PRELIMINARY ENGINEERING
IMX-080-3(315)128--02-77
POLK COUNTY

PLANS OF PROPOSED IMPROVEMENT ON THE
PRIMARY ROAD SYSTEM
POLK COUNTY
PRELIMINARY ENGINEERING

I-35/80 from IA 141 in Urbandale to E of I-35/80/235
 Northeast Mixmaster System Interchange (NEMM)

FIELD EXAM CHECKLIST

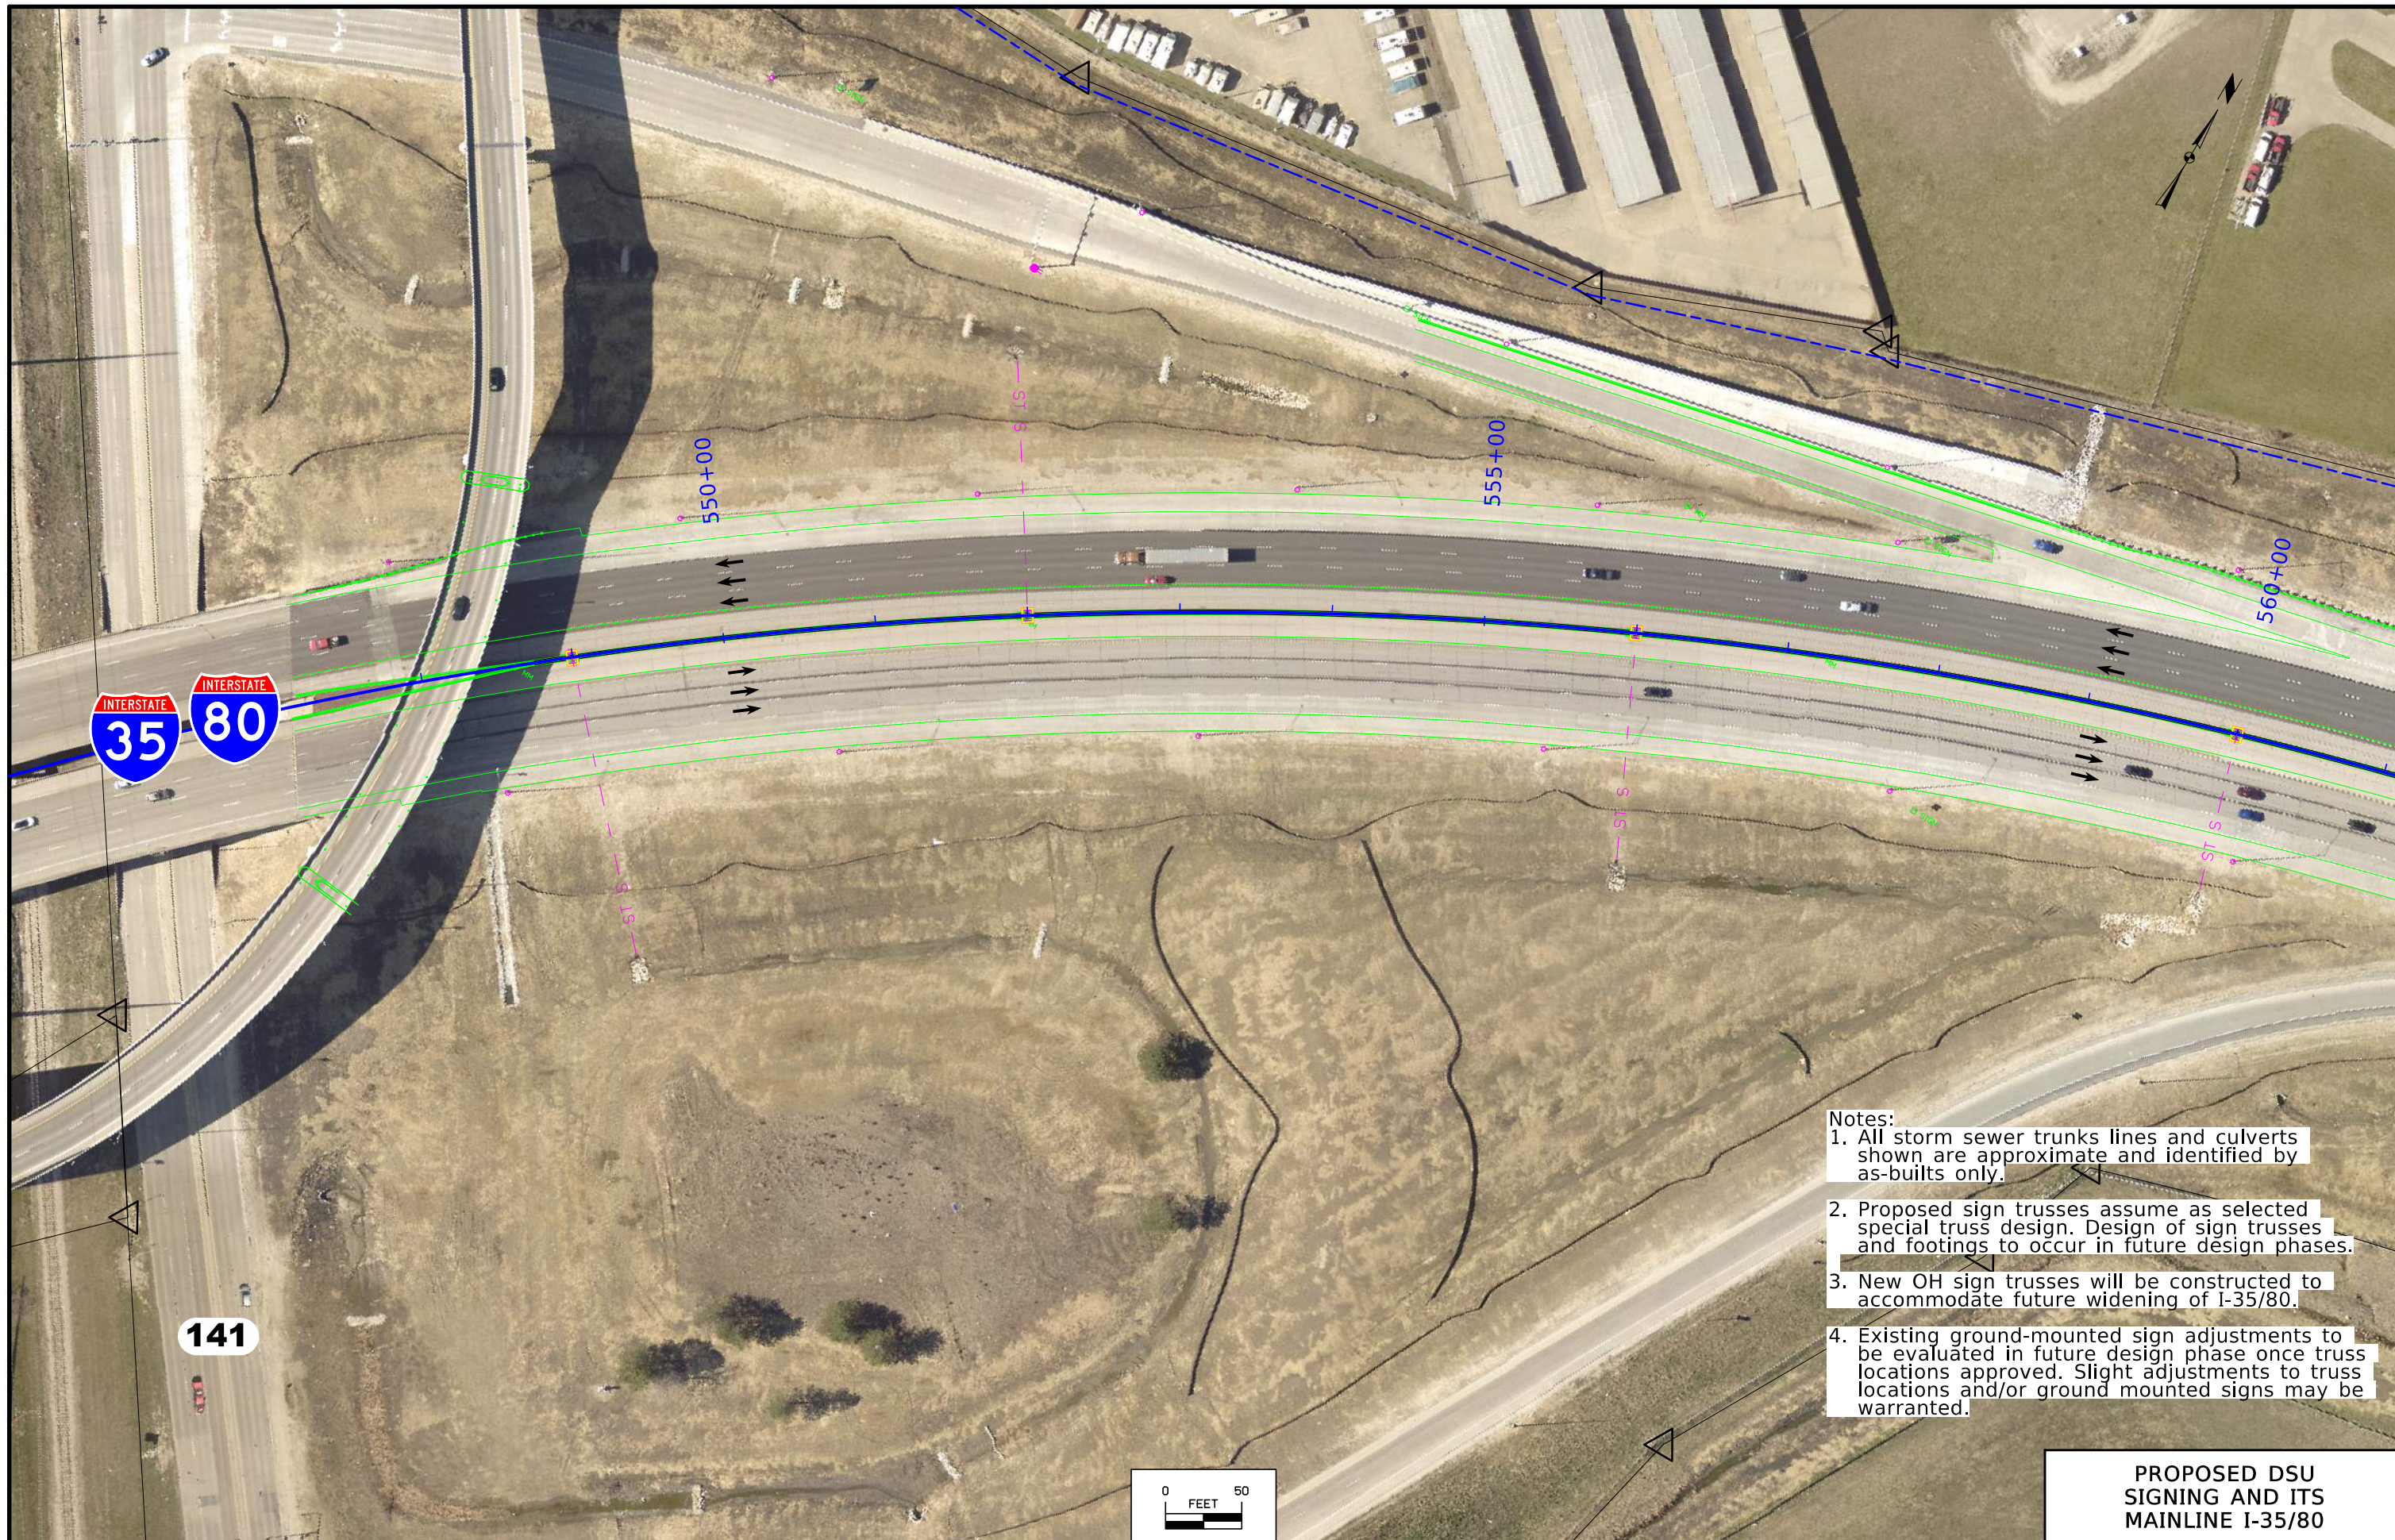
Included NO TRUCKS ON SHOULDER sign (not included in draft MUTCD guidance, however similar sign to that used on WisDOT Madison Beltline).

**PROPOSED DSU
SIGNING AND ITS
MAINLINE I-35/80**

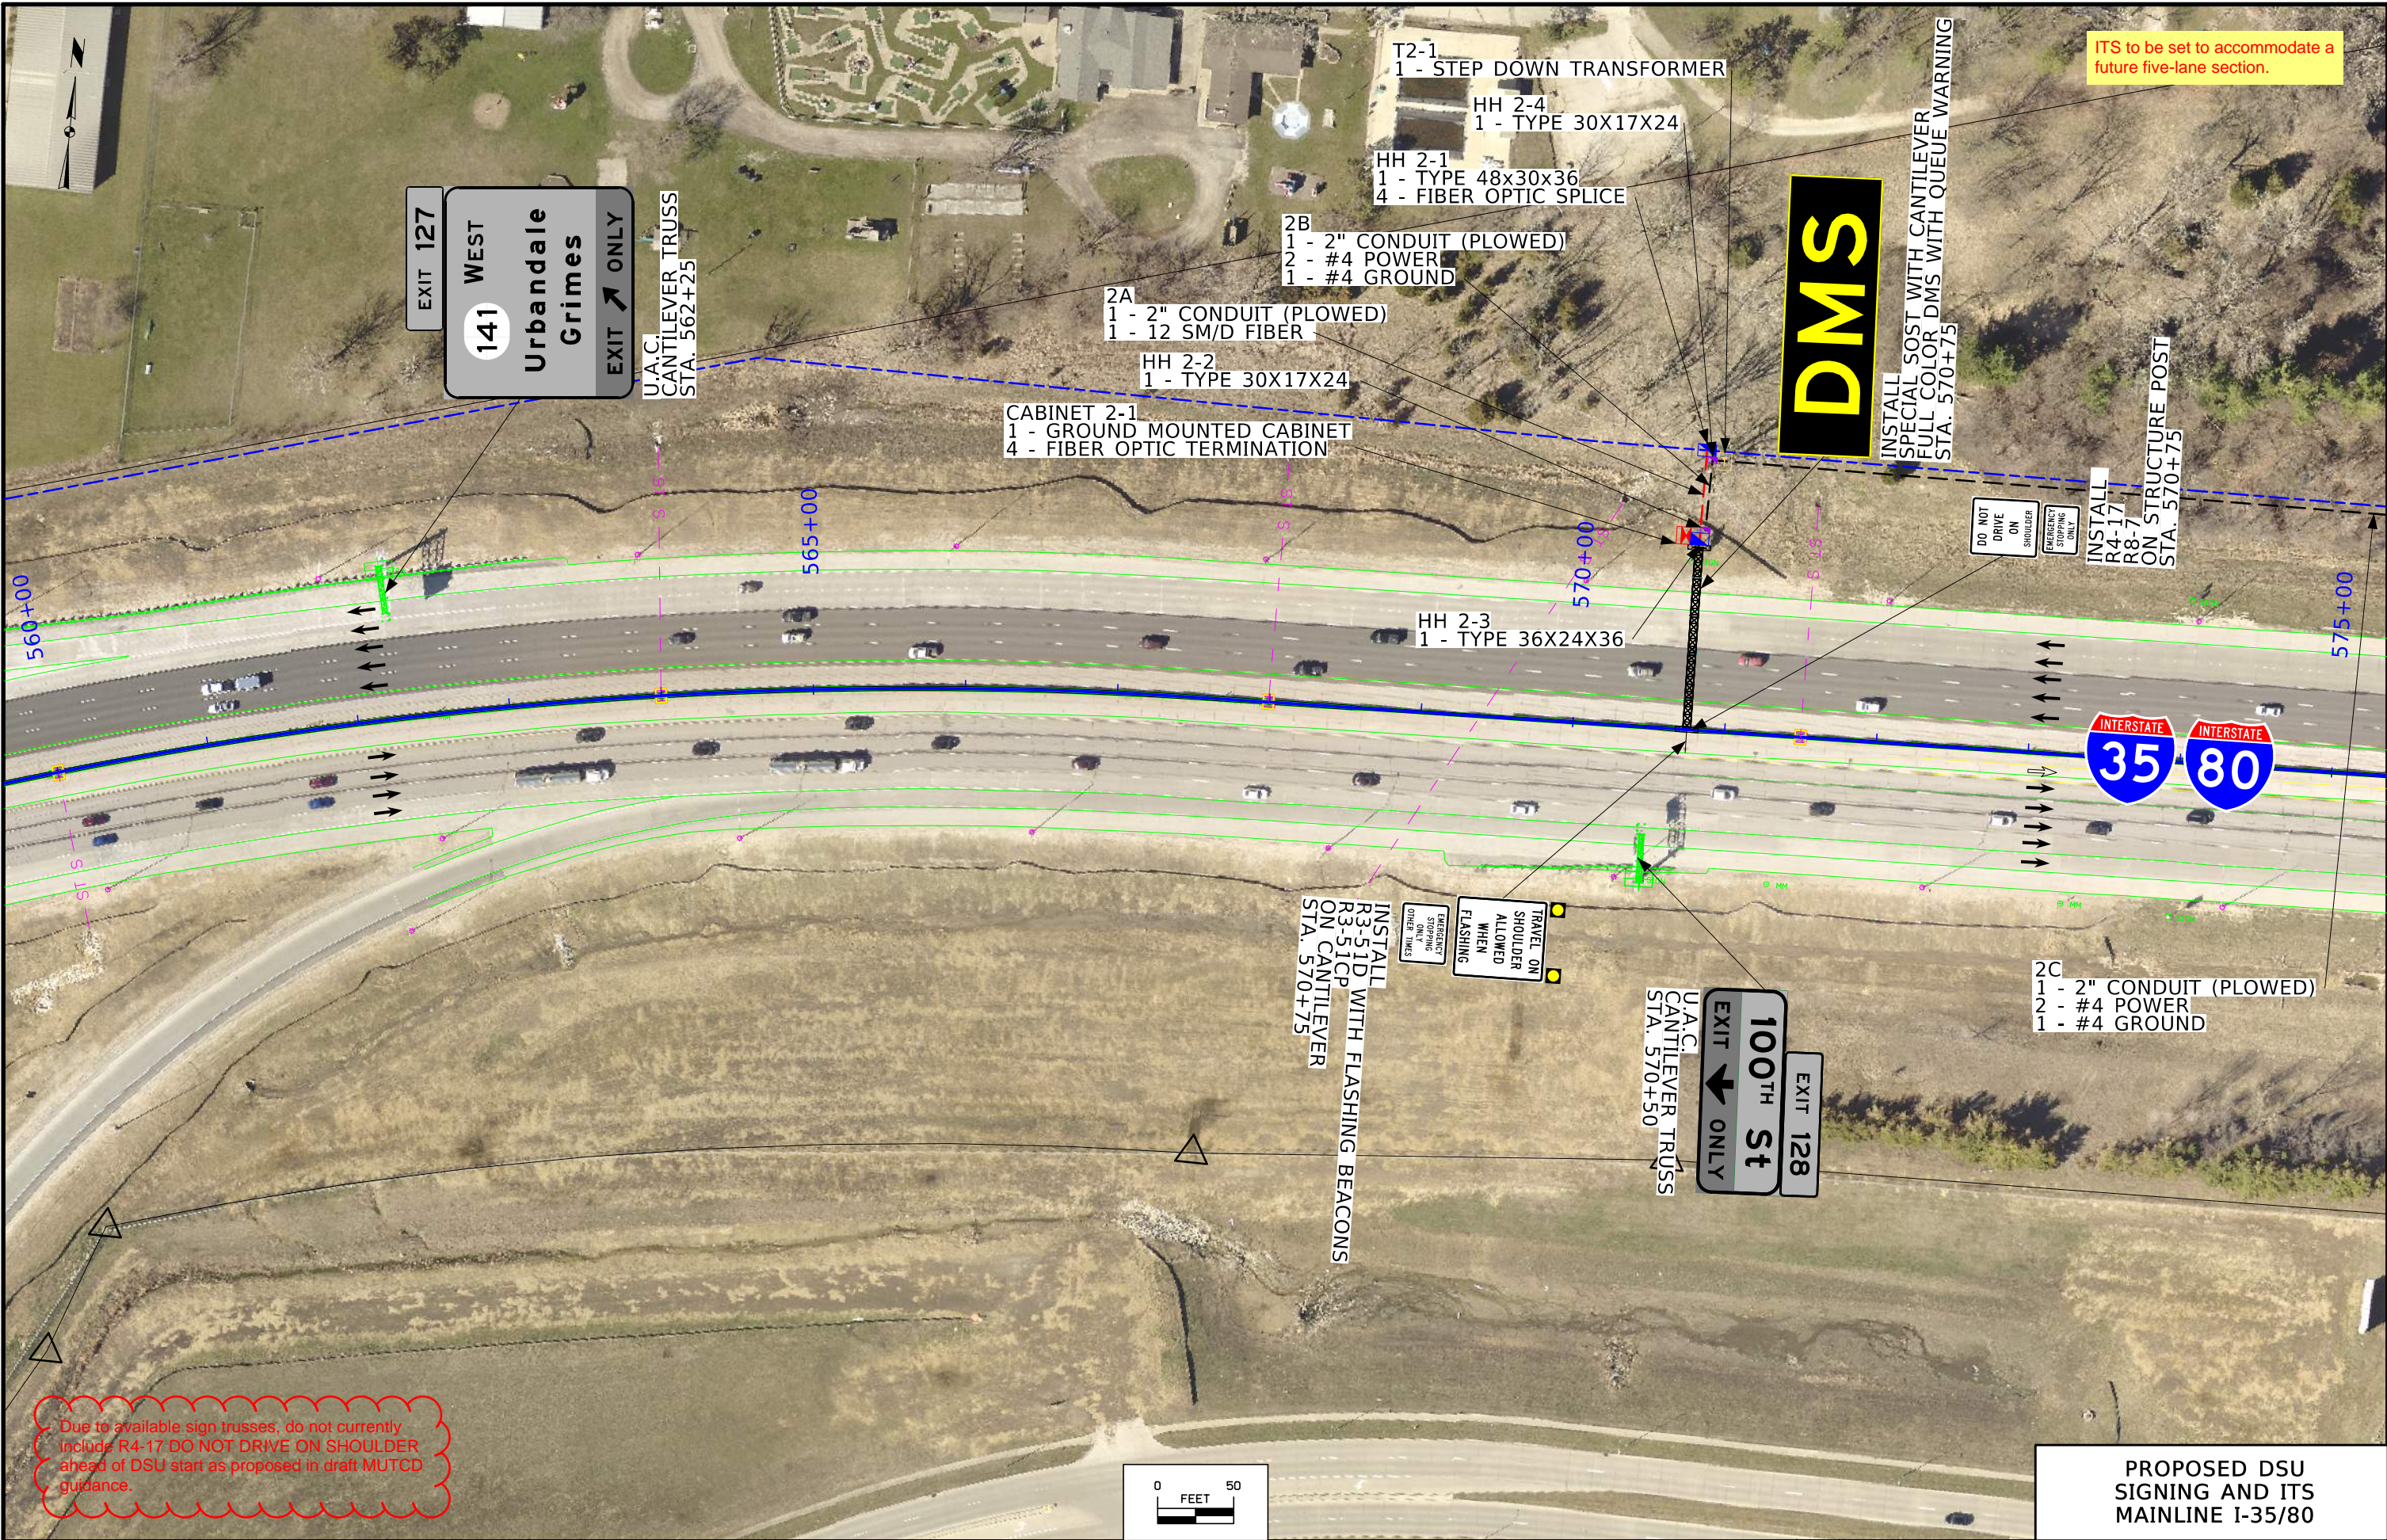
ITS to be set to accommodate a future five-lane section.

Due to available sign trusses, do not currently include R4-17 DO NOT DRIVE ON SHOULDER ahead of DSU start as proposed in draft MUTCD guidance.

**PROPOSED DSU
 SIGNING AND ITS
 MAINLINE I-35/80**

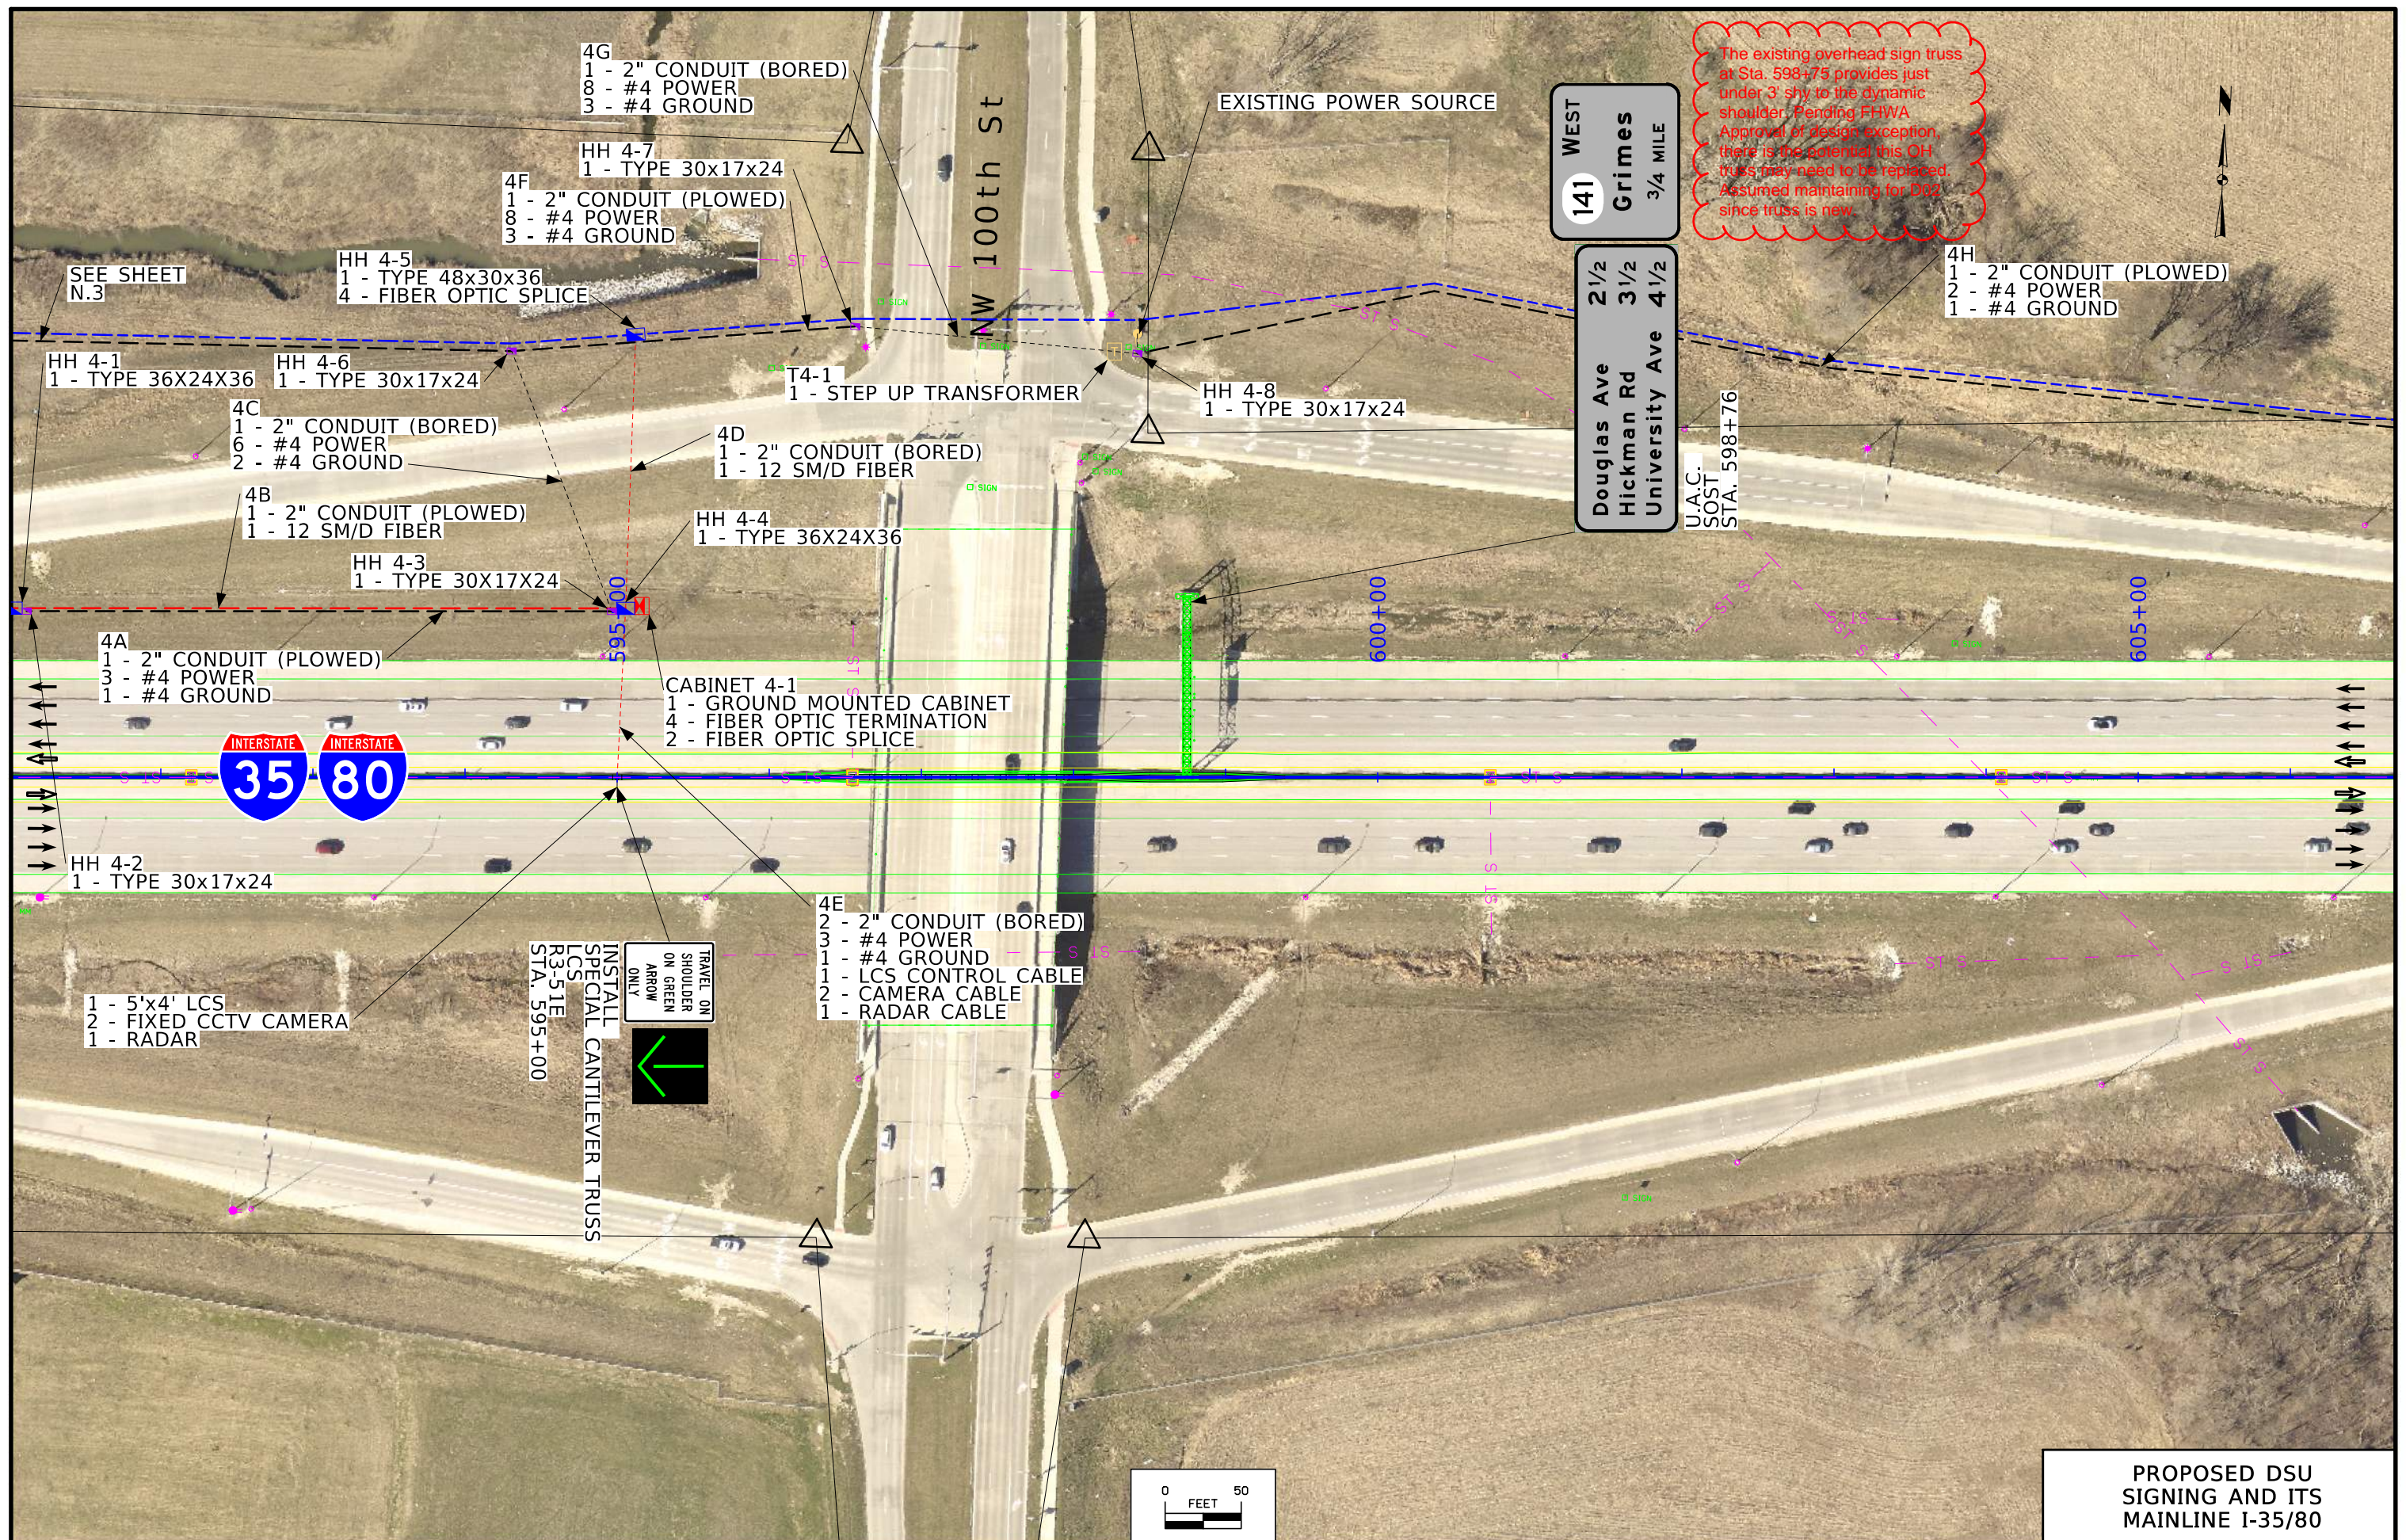
The existing overhead sign truss at Sta. 598+75 provides just under 3' shy to the dynamic shoulder. Pending FHWA Approval of design exception, there is the potential this OH truss may need to be replaced. Assumed maintaining for D2 since truss is new.
